Amphenol Taiwan Corporation Product Change Notification

Part Numbers Concerned :	GSB4164X5XHR	Originator:	Debby Hung
Customer P/N:		Issue Date:	2020/04/27
Product Description:	USB 3.1 A TYPE PLUG, SMT 0.3mm OFFSET CENTER LINE.	PCN NO:	1210-19000781
Distribution:

Product Change Notice

Update D/C and T&R and Tray packing drawing and quantity.

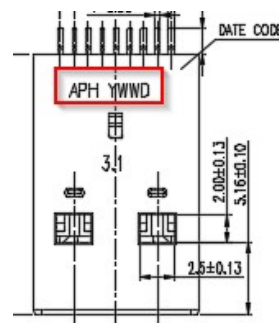
Update D/C: YWWD

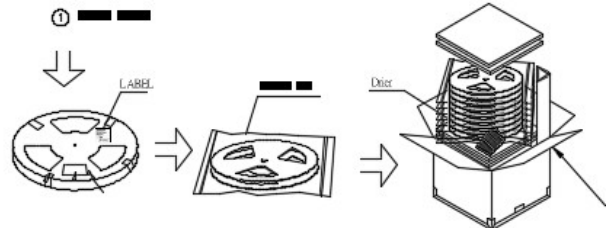
T&R : One by one packing

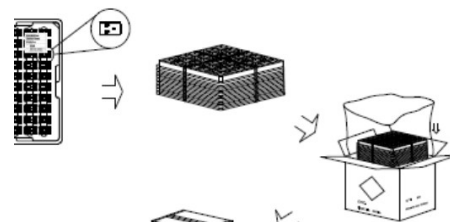
Tray add big PE bag.
